January 31, 1985

HOPE CREEK GENERATING STATION
DOCKET NO. 50-354
RIVERBORNE MISSILES SUPPLEMENTAL INFORMATION

HOPE CREEK GENERATING STATION
PUBLIC SERVICE ELECTRIC AND GAS COMPANY
RESPONSES TO QUESTIONS IN JANUARY 9, 1985 LETTER
RIVERBORNE MISSILES

DATUM AND WATER
LEVEL RELATIONSHIP

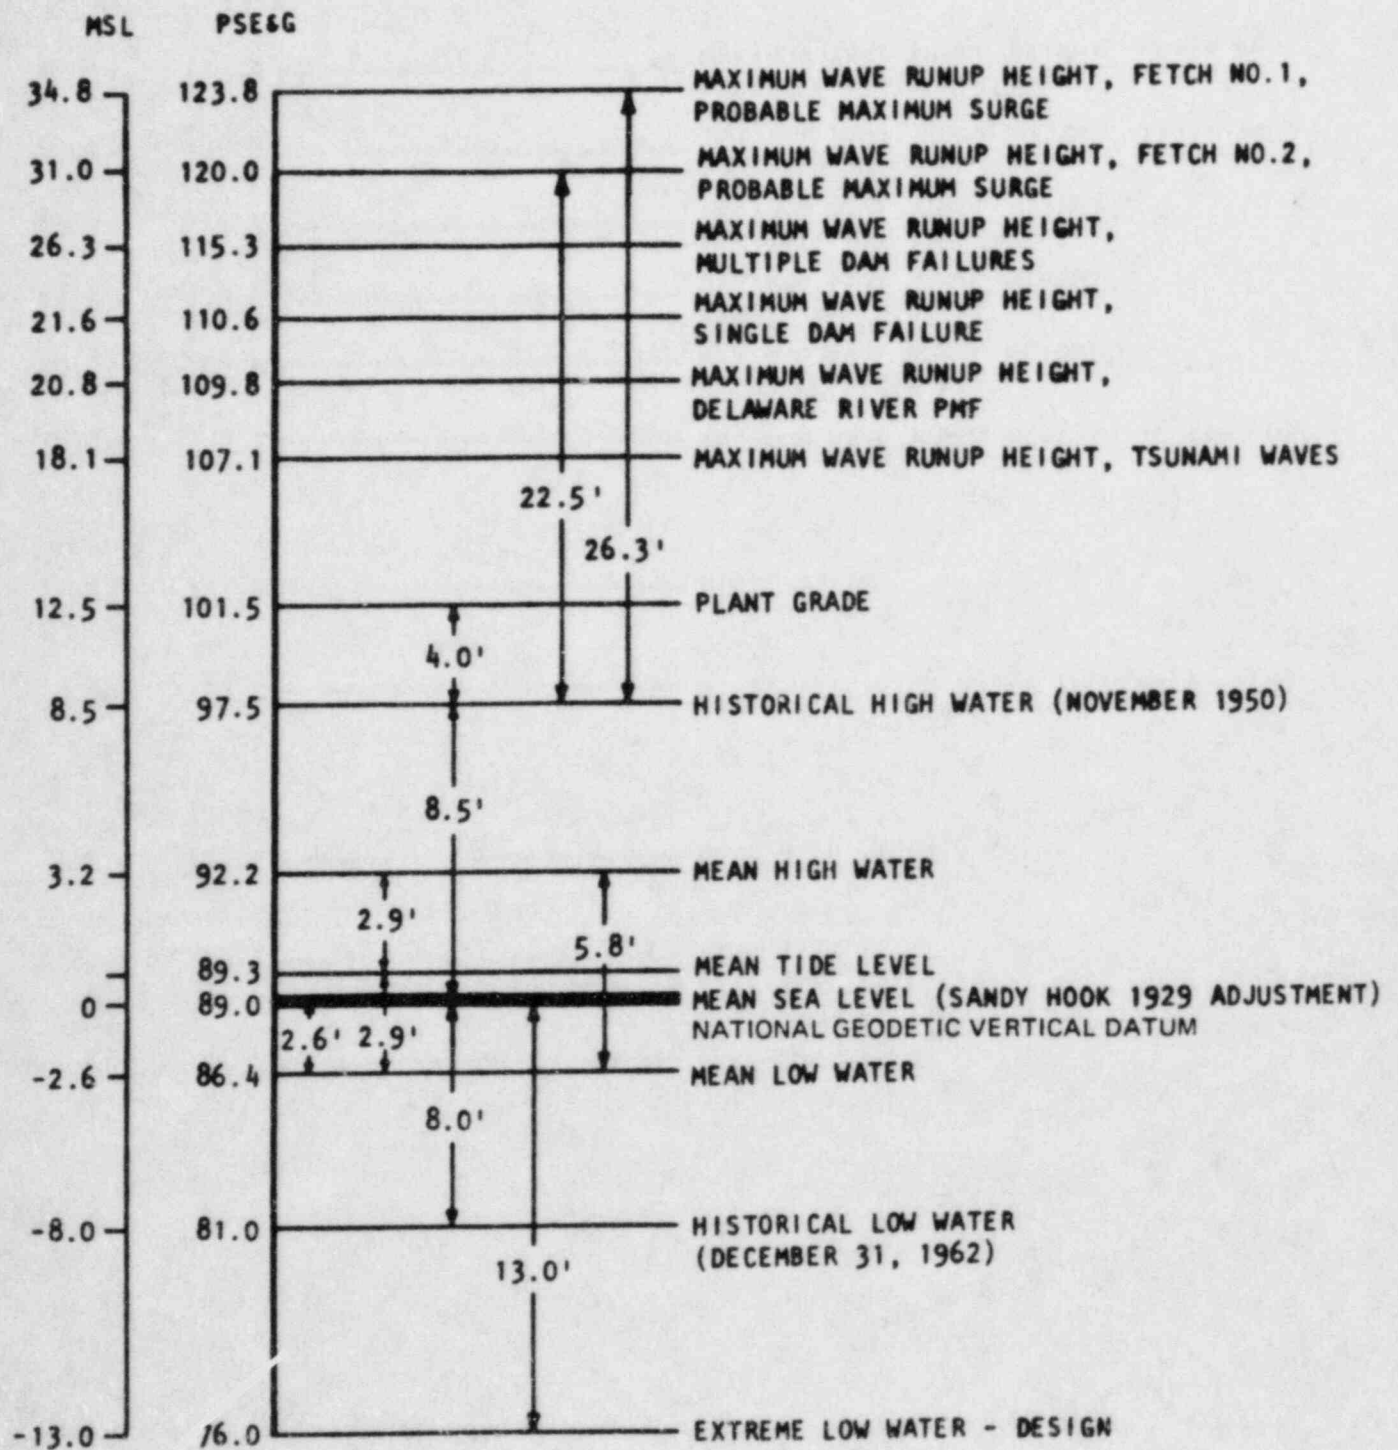
On page 5 of the ADL Report, it is stated that grade level is approximately 14 ft. above Mean Low Water Level. In Table 2, footnote 4, page 7, it is stated that an increased water depth of 12 ft. over Mean Low Water results in a water level which is about 3 ft. below plant grade (rather than 2 ft., as would result from the statement on page 5 of the ADL Report). Is there a reason for the difference between the statements in page 5 and in Table 2?

The elevation and water height numbers in the ADL Report are approximate to within about 1 foot. This approximation does not compromise the analysis or change any conclusion. The most recent measures of datum and water level relationships are contained in Figures 2.4-3 of the Hope Creek Final Safety Analysis Report. A copy of Figure 2.4-3 dated October 1983 is attached.

It can be seen from this figure that plant grade is actually 15.1 ft. above Mean Low Water. Under the postulated extreme wind scenario the water level could rise up to 12 ft. over Mean Low Water. In this case, the water level would still be about 3 ft. below plant grade.
